Adequacy Review Response TR-4 / Lyons Quarry / M1977-141

DRMS Comment Crosswalk

Aggregate Industries - WCR, Inc.

112d Reclamation Permit Operations
Technical Revision

Figure C-3 – Reclamation Plan Map – Exhibit F

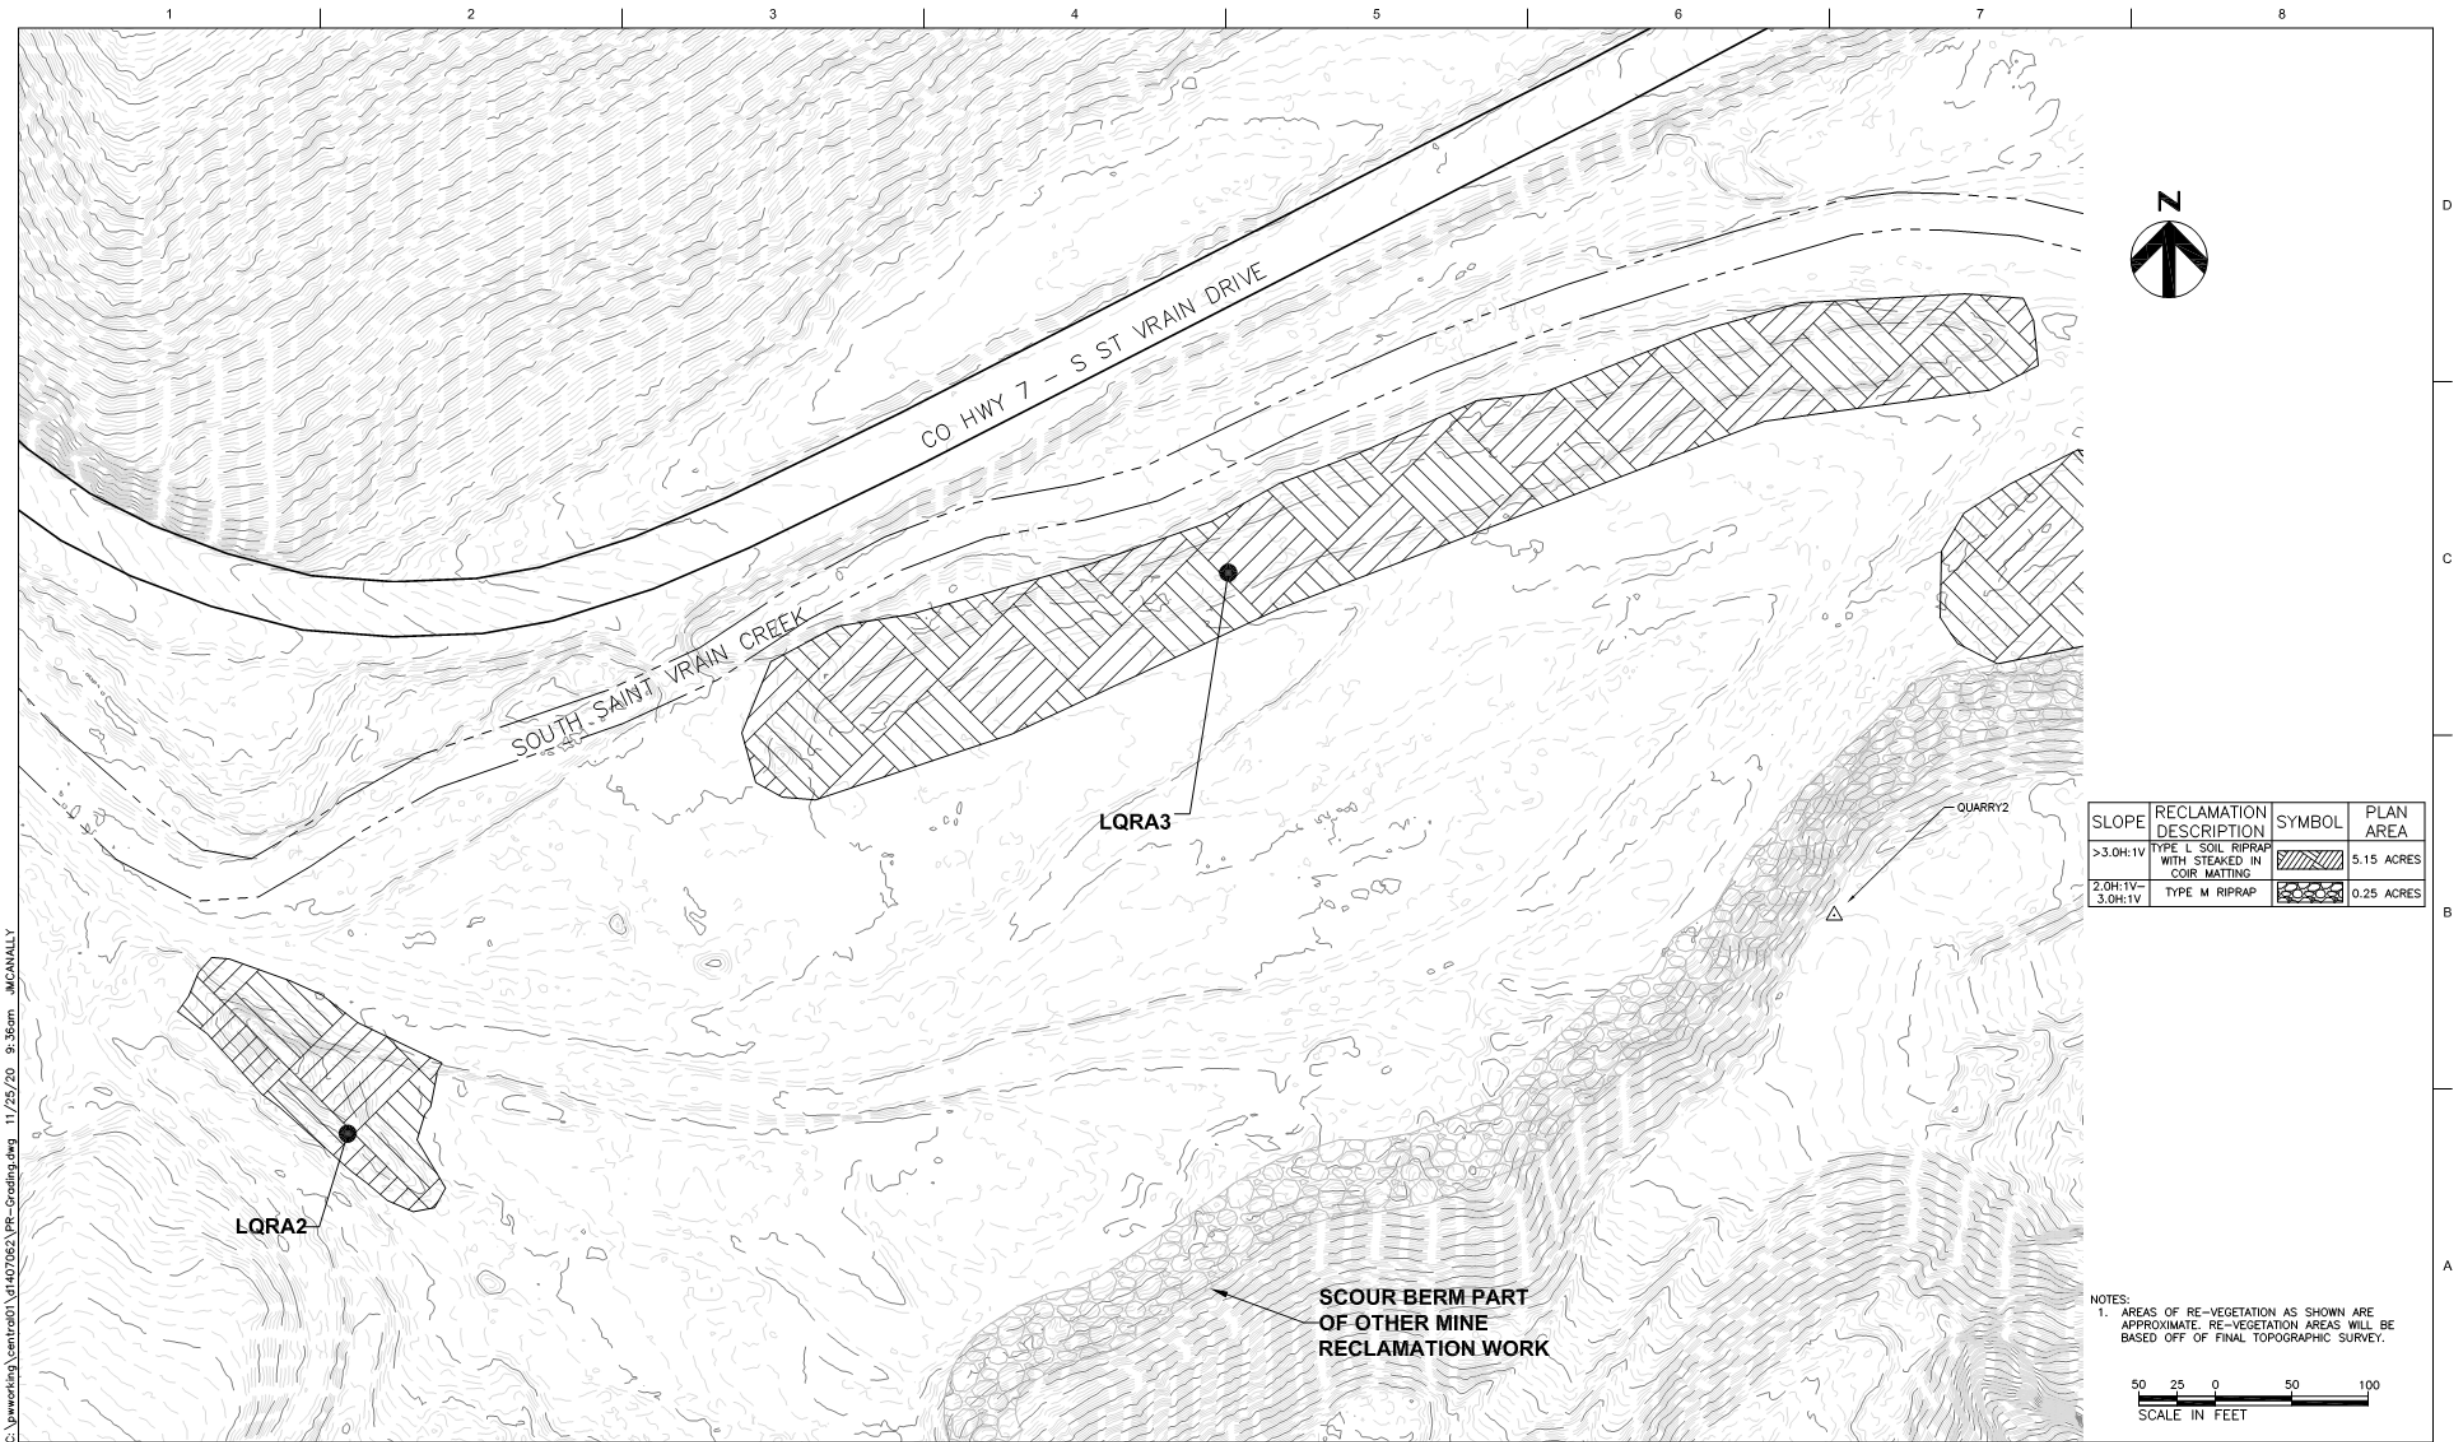
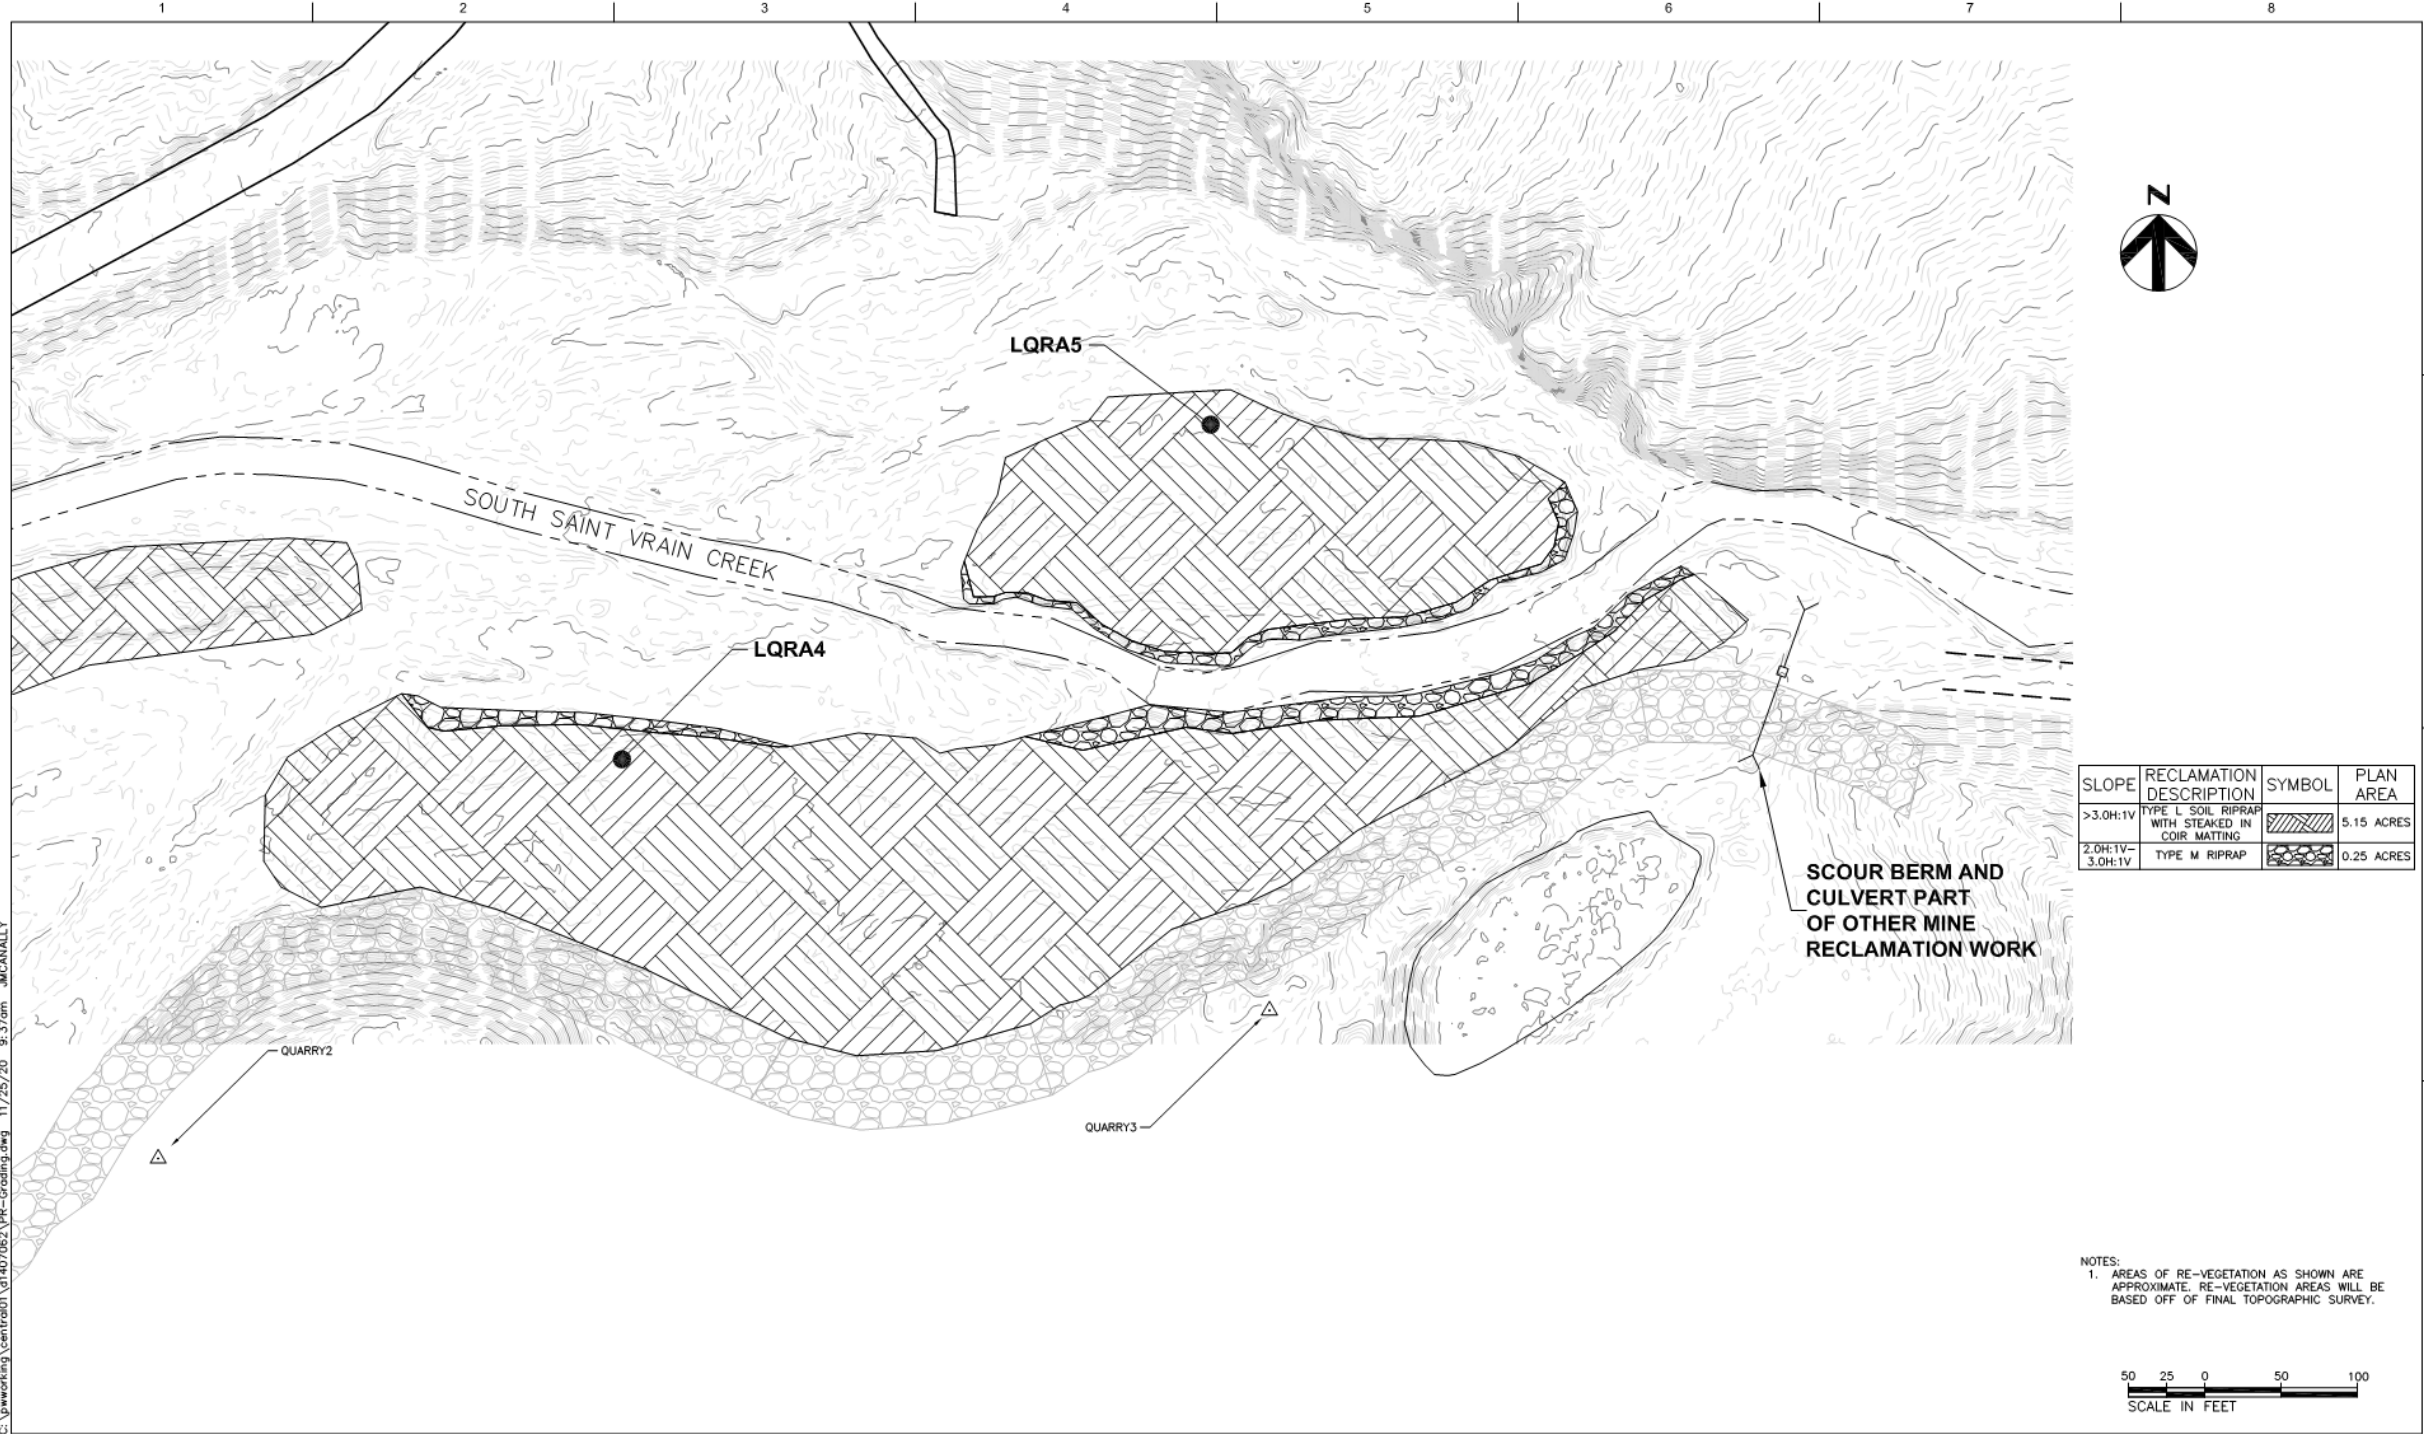
3	On Page 4, in Table 1 – Lyons Quarry Reclamation Areas 2-5, the total acreage estimated for all four disturbance areas is 2.78 acres. This does not correlate with the acreages shown on Figures C-2 and C-3 Reclamation Plan Maps which show the four disturbance areas to total 5.9 acres, of which, 5.6 acres will be reclaimed with Type V Soil Riprap with staked in coir matting at slopes of 3H:1V or flatter, and 0.3 acres will be reclaimed with Type M Riprap at slopes of 2H:1V - 3H:1V. Please clarify and/or correct this discrepancy. Additionally, if any of the acreages are revised in Table 1, please ensure the associated volumes are revised accordingly.	Figures, narrative and Table 1 have been revised to be in concurrence with each other.
4	On Page 6, in the 1st paragraph, the text states "In areas where crusher fines are removed below the grade of the floodplain, clean fill will be brought in either from the vegetated berm (LQRA3) or from areas within the quarry that provide suitable backfill material characteristics. This fill material will be combined with riprap to create a soil riprap mixture." Additional details are needed for these tasks in order for the Division to calculate the required financial warranty for the proposed reclamation plan. Firstly, please specify the reclamation areas which will require crusher fines to be removed below the grade of the floodplain. Secondly, please explain where the riprap will be derived for the soil riprap mixture (sorted from on-site material and/or imported). Lastly, please describe the type of equipment which will be used for transporting backfill material from LQRA3 (or elsewhere on site) to the areas requiring backfilling, and for mixing and placing the soil riprap mixture into these areas.	Text in Page 6 Paragraph 2 has been revised to specify that LQRA4 and LQRA5 will be excavated below grade for crusher fines removal. Riprap for the soil riprap backfill material will be sourced on site and a section has been added to ITEM 6.0 of the reclamation plan for producing this material.

11	Please ensure Figures C-2 and C-3 Reclamation Plan Maps are updated as needed to include the correct volumes for the reclamation areas and to ensure the acreages provided in the map legend correlate with the acreages provided in the revision text.	The call outs in the figures have been revised to reflect the correct volumes and acreages.
12	Please ensure Figures B-1 and B-2 Grading Plan are updated as needed to reflect the correct labels (e.g., LQRA4, LQRA5) and volumes for the reclamation areas.	The call outs in the figures have been revised to reflect the correct volumes and acreages.
13	In the Exhibit L – Reclamation Costs, additional details are needed in order for the Division to calculate the required financial warranty for the proposed reclamation plan. Please provide the following additional information:	
13a	Please provide more details for the Mobilization/Demobilization task, including the anticipated type and number of equipment to be mobilized/demobilized for reclamation, and the approximate distance to the nearest location where such equipment can be obtained.	The Mob task was proportionately calculated based off the contractor bidding numbers from the Quarry Reclamation last year. The type/equipment was going to include the heavy equipment performing the re-grading of the quarry but could be much smaller if the floodplain work is done separately from the quarry work. Section 5.1, Item 1.0 has been revised to include the type and number of equipment to be mobilized and where this equipment can be locally sourced.

9	On Figure C-3 – Reclamation Plan Map, the labels for reclamation areas LQRA 4 and 5 appear to be switched, as the text refers to LQRA4 as the crusher fines deposit within the staging area, and LQRA5 as the crusher fines deposit across the creek channel. Please correct these labels.	These call outs have been revised on Figure C-3
10	On Figure C-3 – Reclamation Plan Map, the reclamation area located north of the creek channel (labeled as LQRA4 on the map – but should be LQRA5 as mentioned above) appears to be located near an existing building which is not shown on this map, but is shown on Figures 1.2 and 1.3 included with the revision. Please describe any anticipated impacts to this structure by the proposed reclamation plan. What is the approximate distance between this structure and the nearest reclamation area?	The structure that is referenced was heavily damaged in the 2013 flood. Aggregate removed the building remains and foundation in 2017.
